**PAINT BRUSH HILLS FILING NO. 14**  
 A REPLAT OF TRACT E, PAINT BRUSH HILLS FILING 13E, BEING A PORTION  
 OF THE NE 1/4 SECTION 26, TOWNSHIP 12 SOUTH, RANGE 65 WEST OF  
 THE SIXTH PRINCIPAL MERIDIAN, EL PASO COUNTY, COLORADO

FINAL PLAT  
PAINT BRUSH HILLS FILING NO. 14  
JOB NO. 10-014  
DATE PREPARED: 06/26/2020  
DATE REVISED:

SHEET 5 OF 9

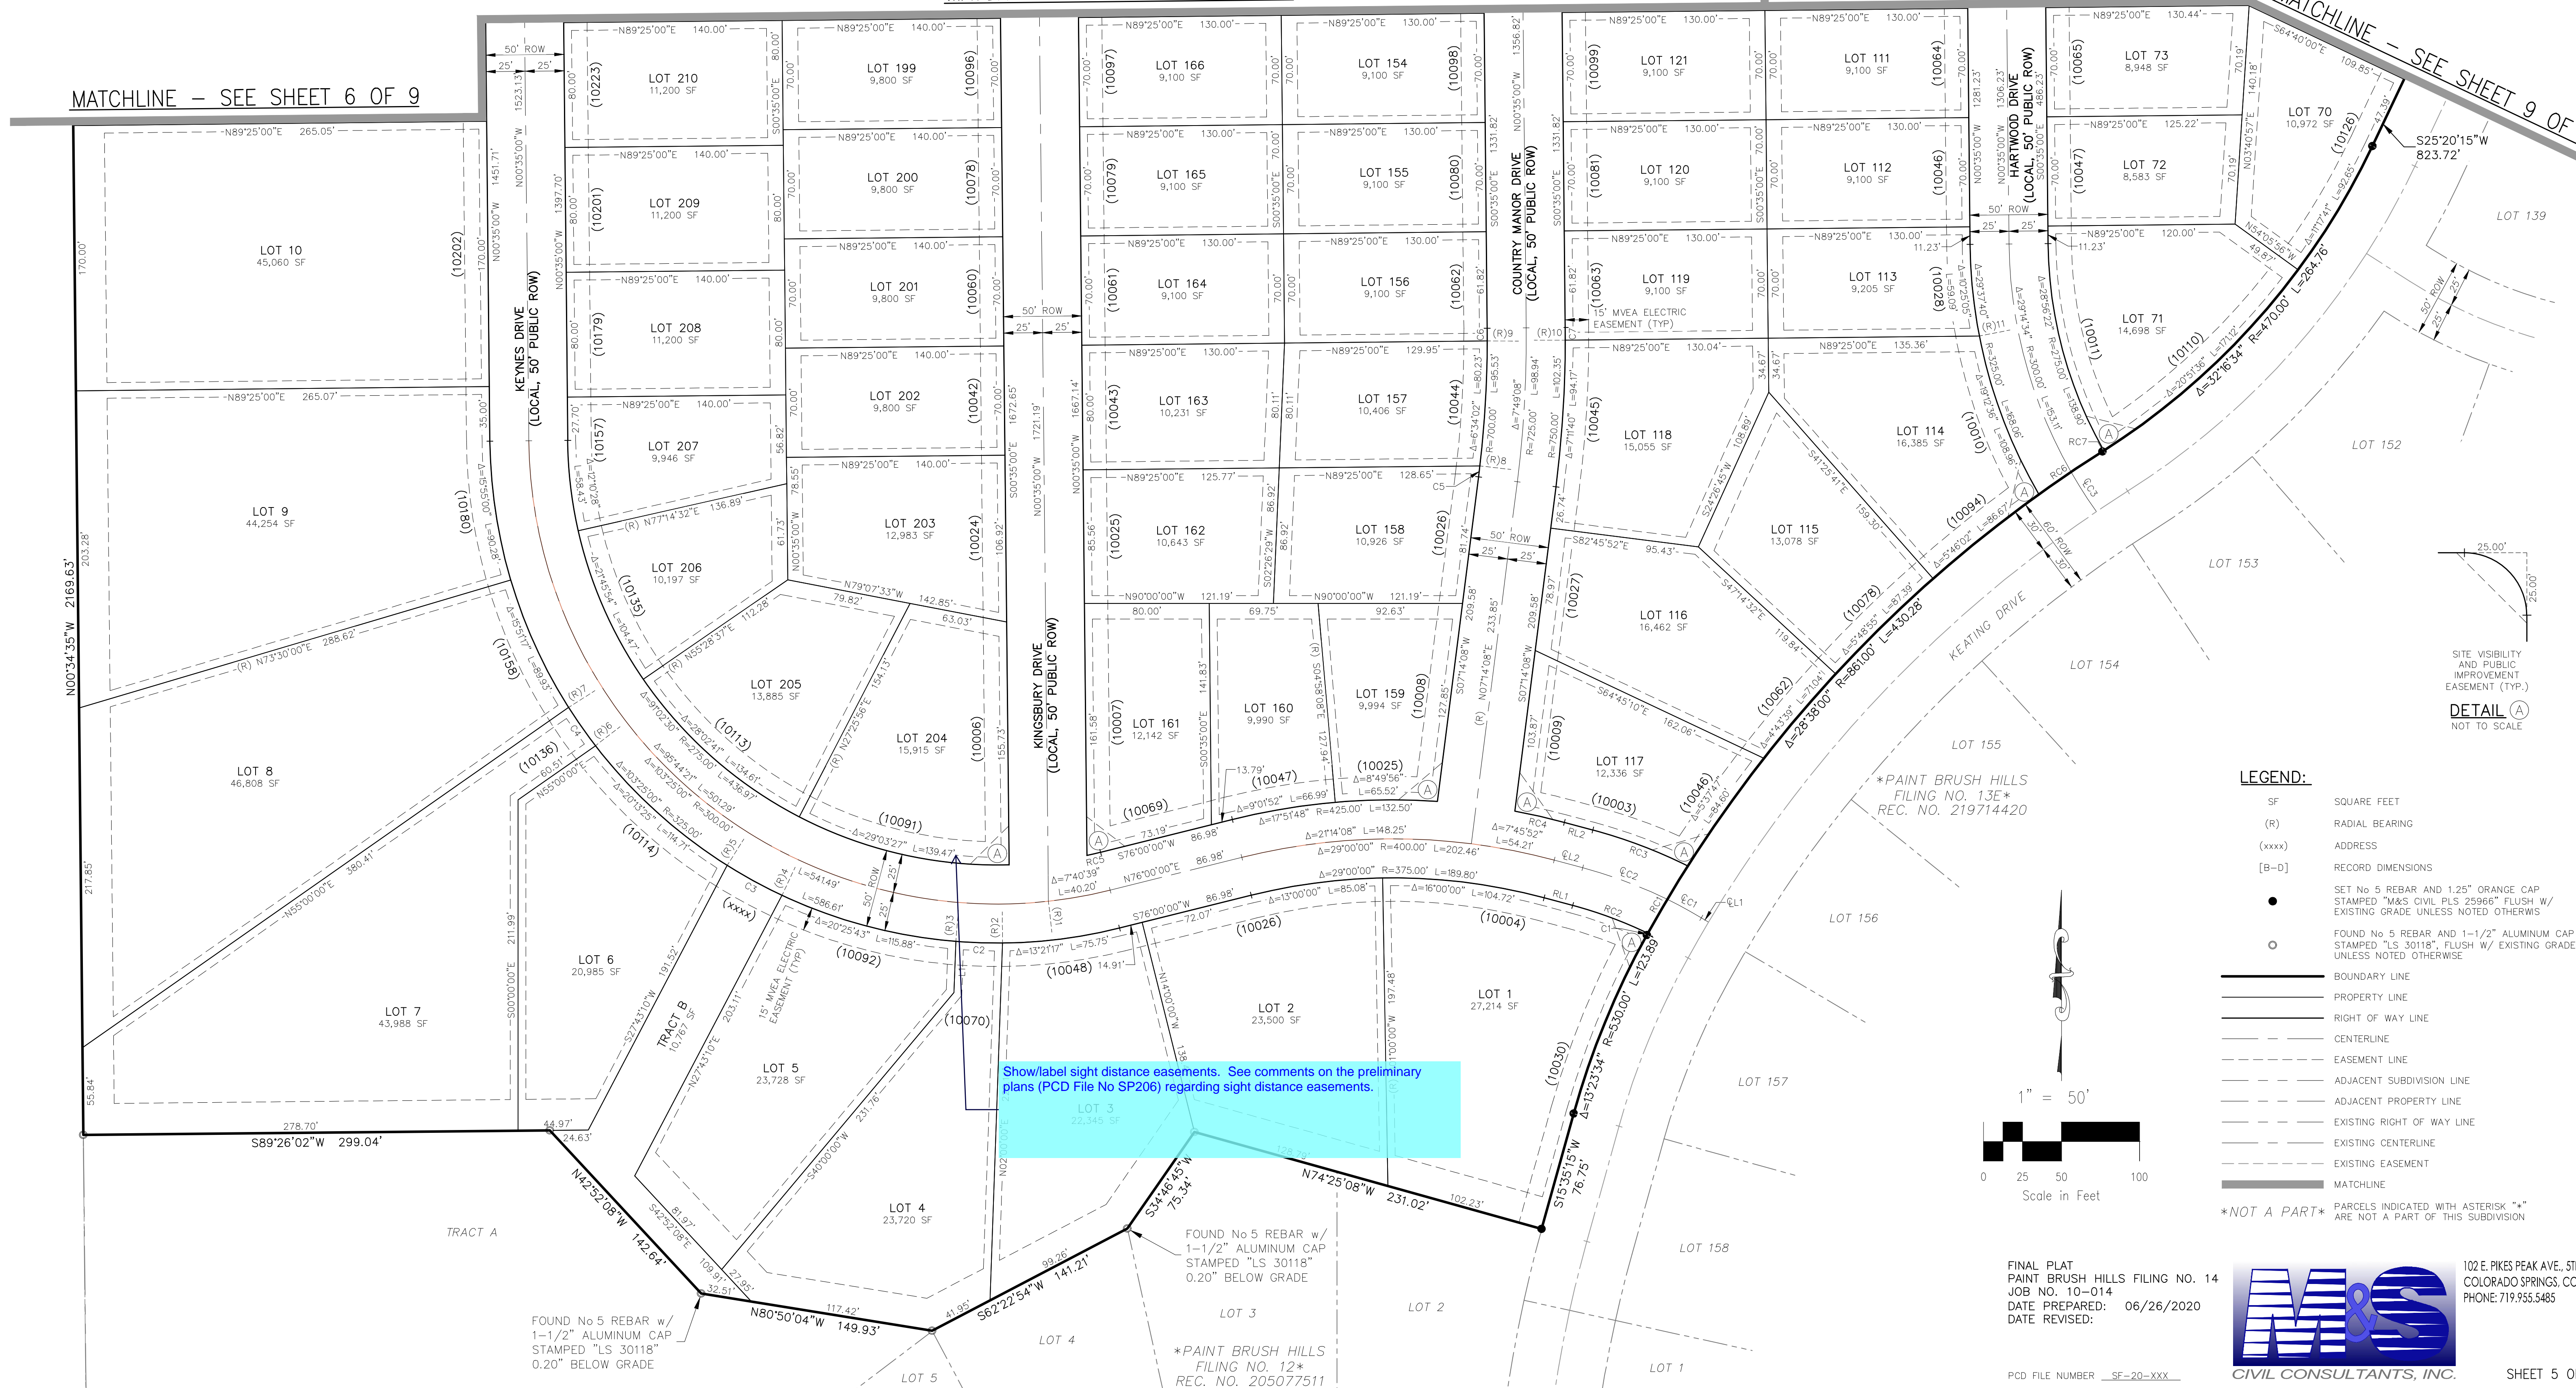
Show/label sight distance easements. See comments on the preliminary plans (PCD File No SP206) regarding sight distance easements.

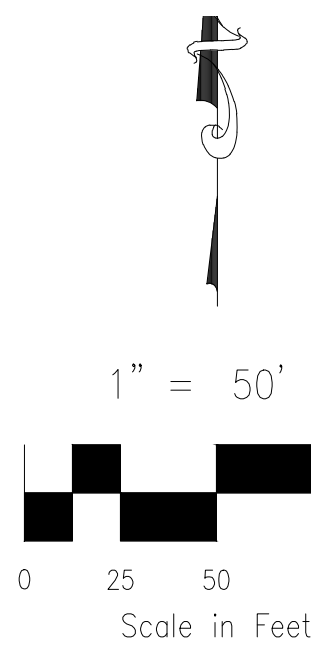
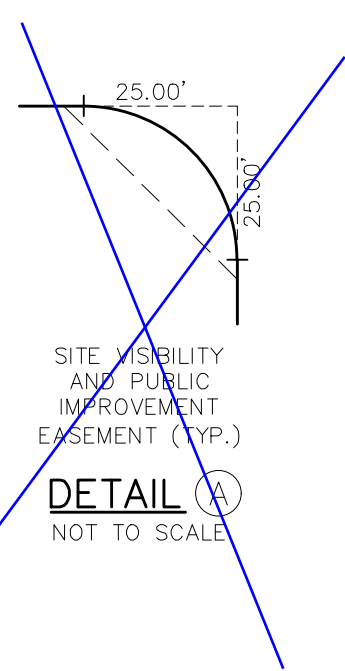
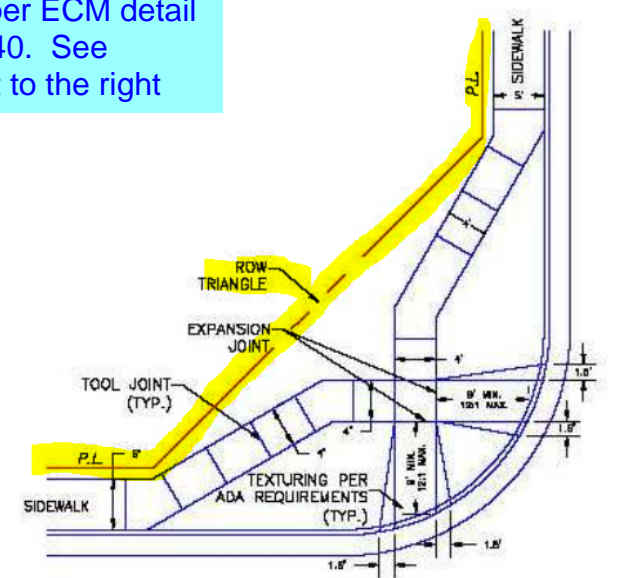
The drainage report identified a drainage swale along the northern lots at the back of sidewalk. Provide sufficient drainage easement for the swale.

Revise all intersection ROW per ECM detail SD\_240. See snippet to the right

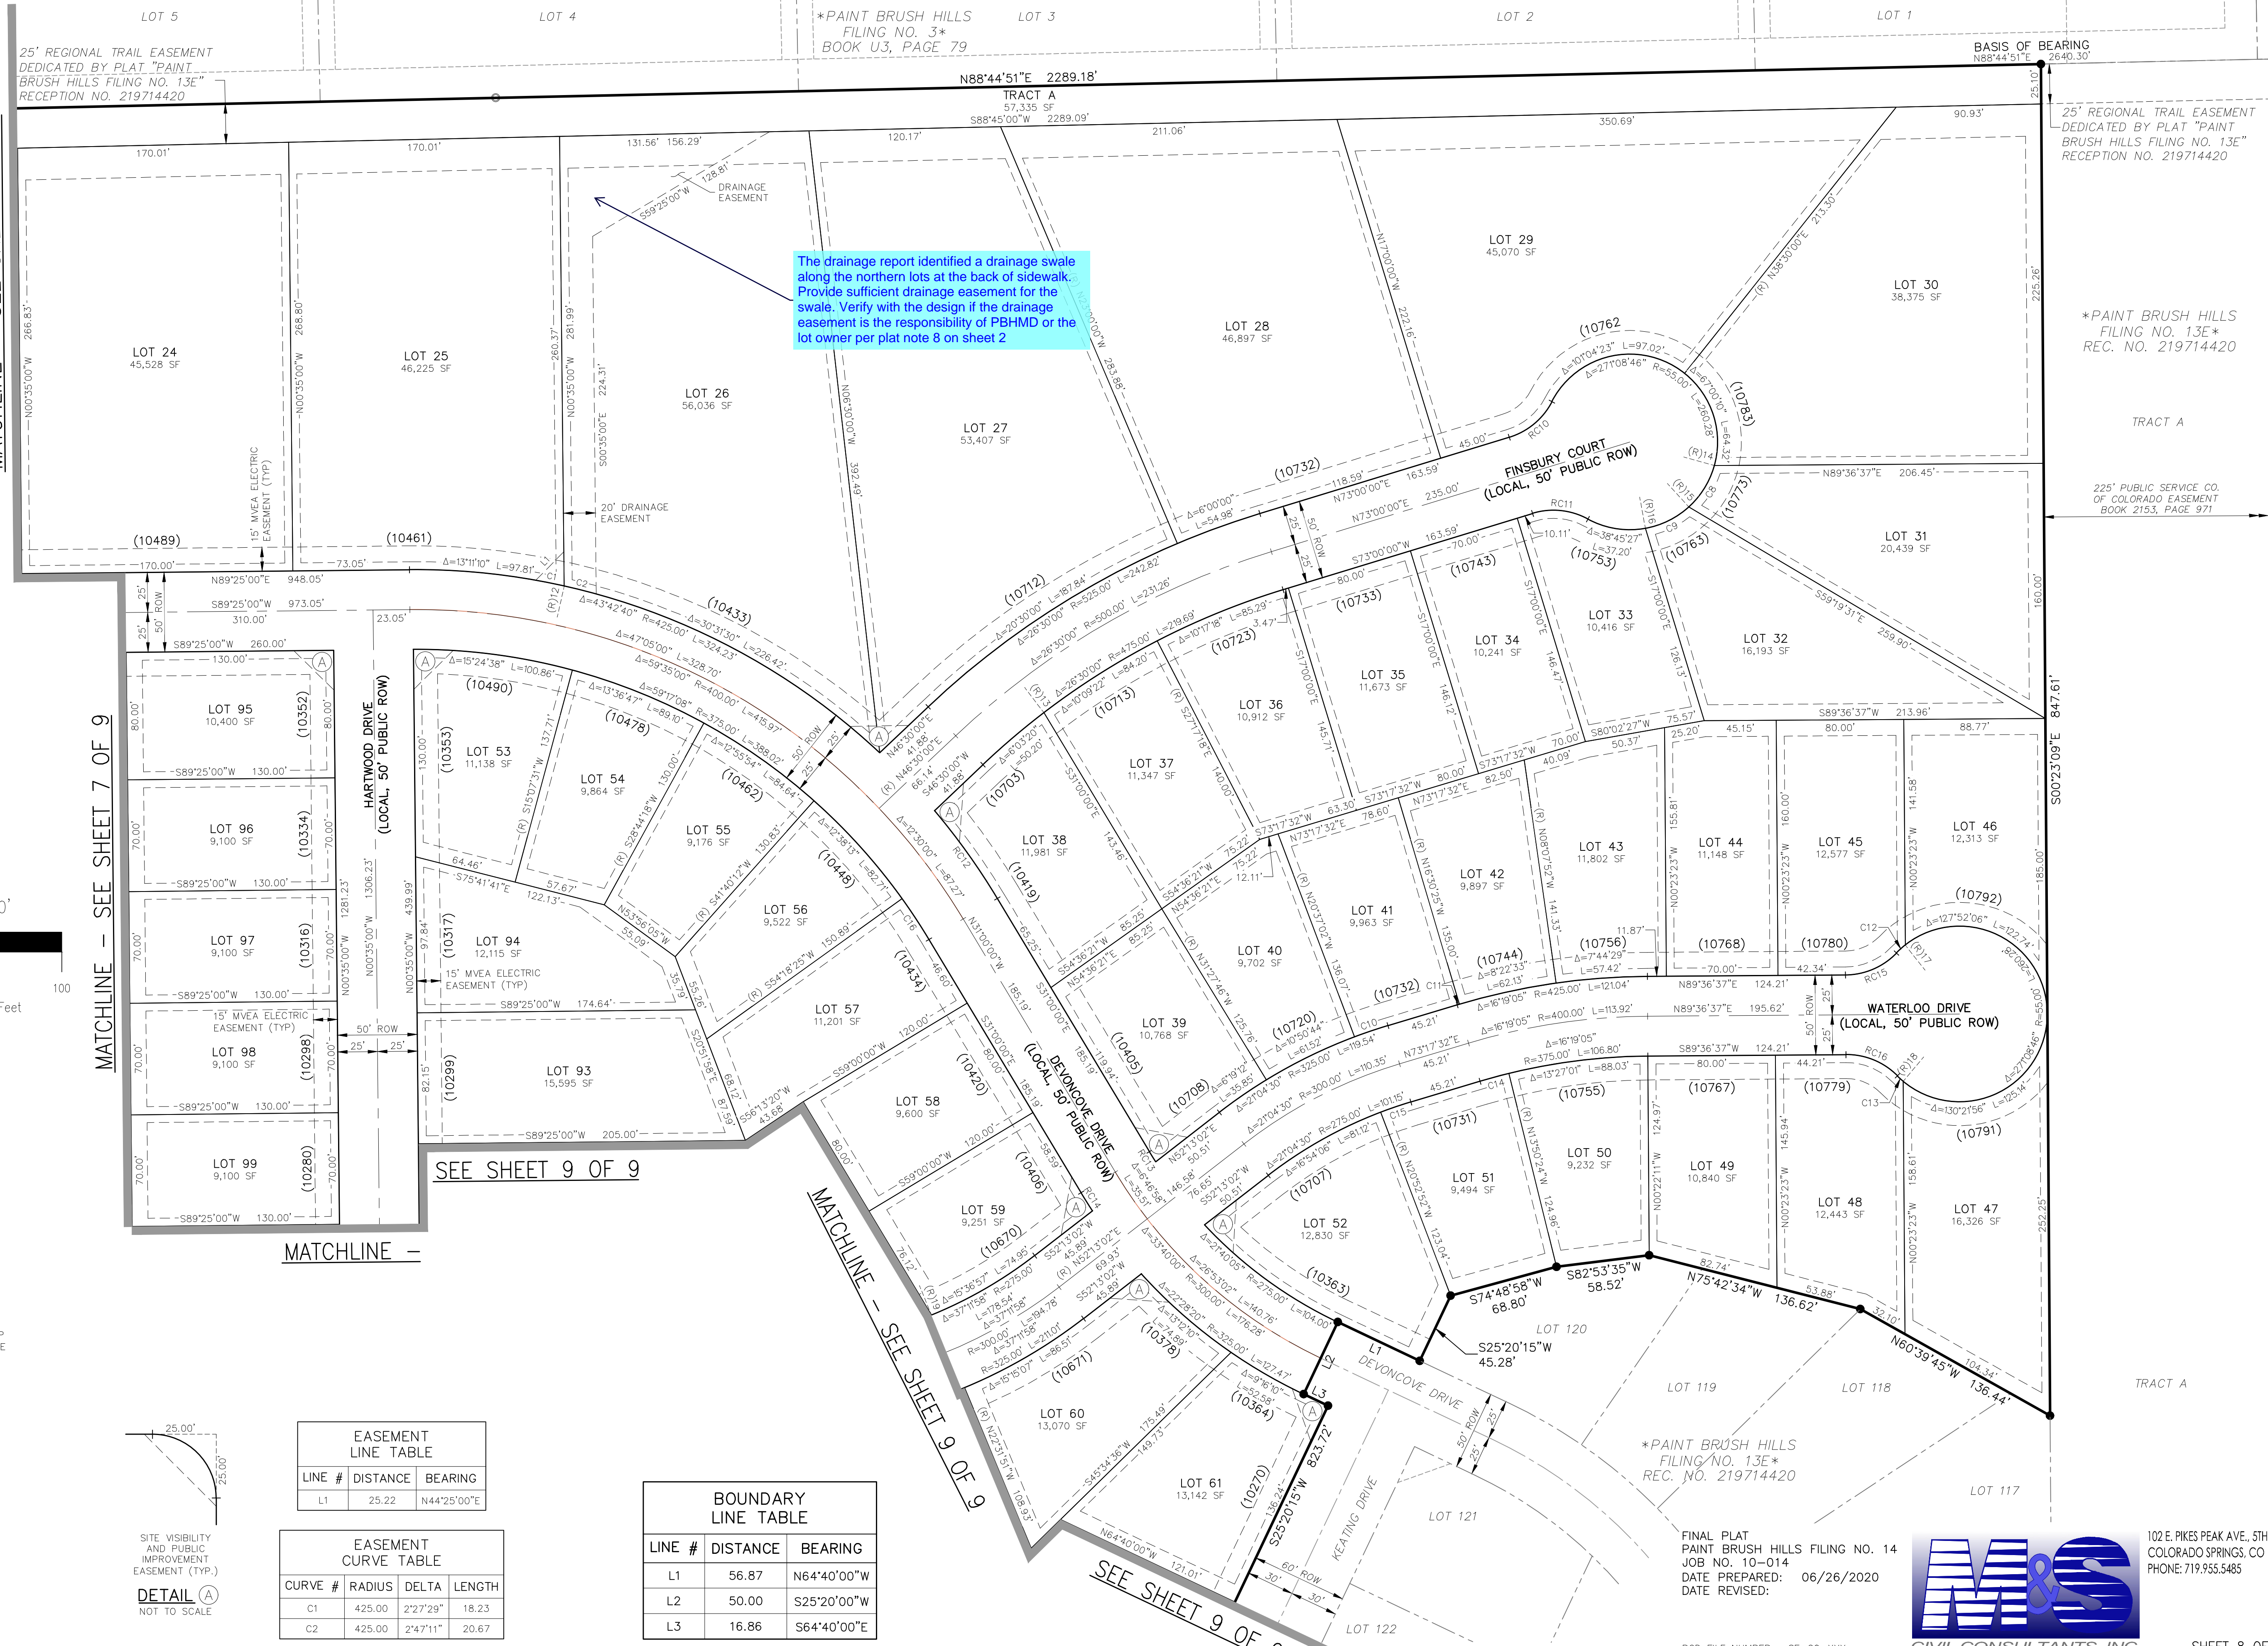
The drainage report identified a drainage swale along the northern lots at the back of sidewalk. Provide sufficient drainage easement for the swale. Verify with the design if the drainage easement is the responsibility of PBHMD or the lot owner per plat note 8 on sheet 2
